Charlotte-Mecklenburg Planning, Design, & Development

SUBJECT: Administrative Approval for Petition No. 2018-048 Novant Health, Inc

CHARLOTTE, MECKLENBURG COUNTY, NORTH CAROLINA REZONING SITE PLAN FOR NOVANT HEALTH, INC. FAMILY MEDICAL CENTER 2701 STATESVILLE ROAD

DATE	April 2, 2018
SCALE	As Noted
JOB NO.	20171316
SHEET	RZ-01

PROPOSED CONDITIONS

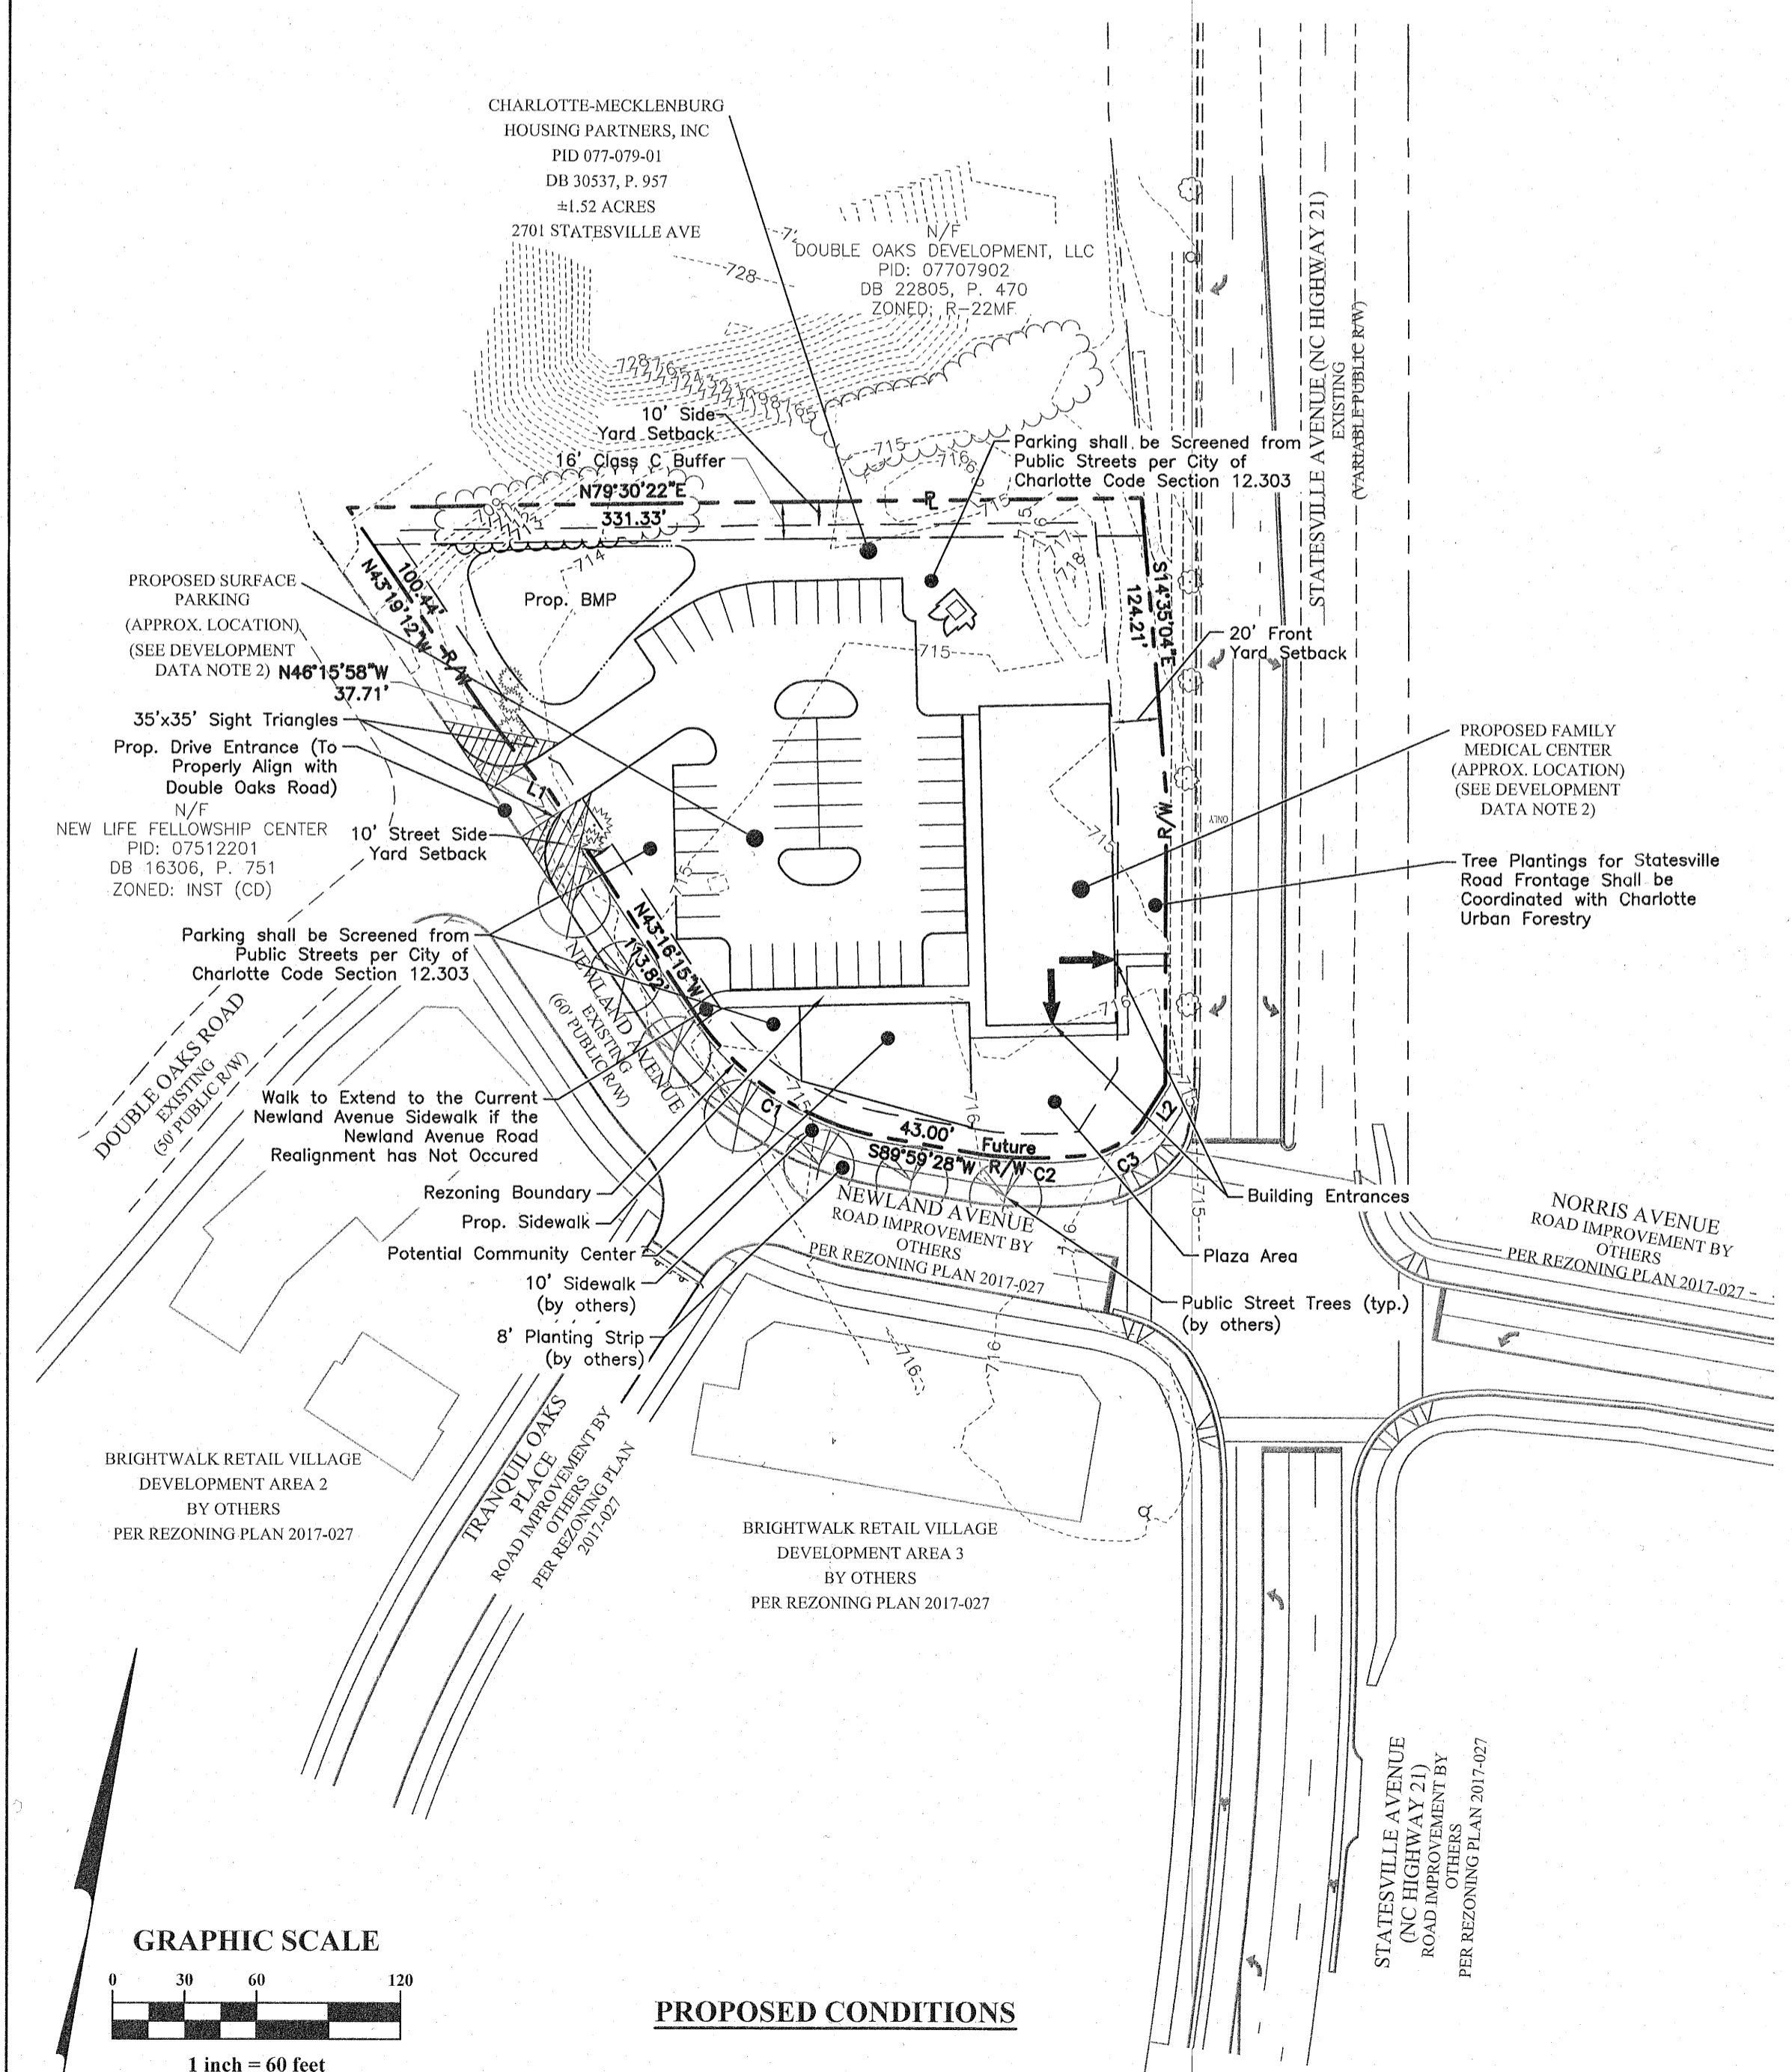
- To allow a modification to the dedication of right-of-way.
